Technical Bulletin

Model: Iris2/Lilac2 (Controller E-310) Da			Dat	ate: 21-Mar-01		No.: RB017008
Subject: E-310 Ver.1.1 (128MB) model release			Prepared by: Chisato Tsuji			
From: Technical Services Dept., GTS Division						
Classification:	Troubleshooting	🛛 Part inf	orma	tion 🗌 Ad	ctior	n required
	Mechanical	Electric	al	🖂 Se	ervio	ce manual revision
	Paper path	Transm	it/rec	eive 🗌 Re	etrof	fit information
	Other ()

Model: Iris2/Lilac2 Controller E-310 Da			Dat	te: 15-Nov-01	No.: RG938001
Subject: "Please Wait", White Line Scans, etc.			Prepared by: Chisato Tsuji		
From: Technical Services Dept., GTS Division					
Classification:	☐ Troubleshooting	Part inf	orma	tion 🗌 Action	n required
	Mechanical	Electric	al	🗌 Servi	ce manual revision
	Paper path	Transm	it/rec	eive 🗌 Retro	fit information
	Other ()

Model: Iris2/Lilac2			Dat	e: 15-Oct-02	No.: RG938002
Subject: E-310	System Version 1.11 Releas	ion	Prepared by: Chi	sato Tsuji	
From: Technical Services sec. Service Planning Dept.					
Classification:	Troubleshooting	Part info	ormat	tion 🛛 🖾 Actior	n required
	Mechanical	Electric	al	Servio	ce manual revision
	Paper path	🗌 Transm	it/rec	eive 🗌 Retro	fit information
	Other ()

Figure 1 Front view - not fully seated

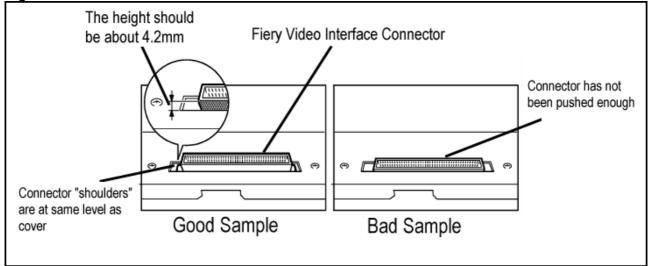
- 1. Some units were shipped from the factory with the connector in the condition shown in Fig. A below, i.e. the connector was not sticking out at least 4.2mm from the unit (as it should).
- 2. The connector clears the unit side face by at least 4.2mm, but the controller unit was not inserted far enough into the interface unit at installation (Fig. 1-4 below).

- 1. Shut down the Fiery system and turn off the copier main power.
- 2. Pull out the Fiery controller unit and check to see if the video interface connector sticks out from the unit 4.2mm or more (Fig. A). If not, then follow the instructions in Fig. B below.
- 3. Fully reseat the controller all the way into the interface unit until the connector fully engages (Fig. 5, 6).
- 4. Turn on the copier main power.
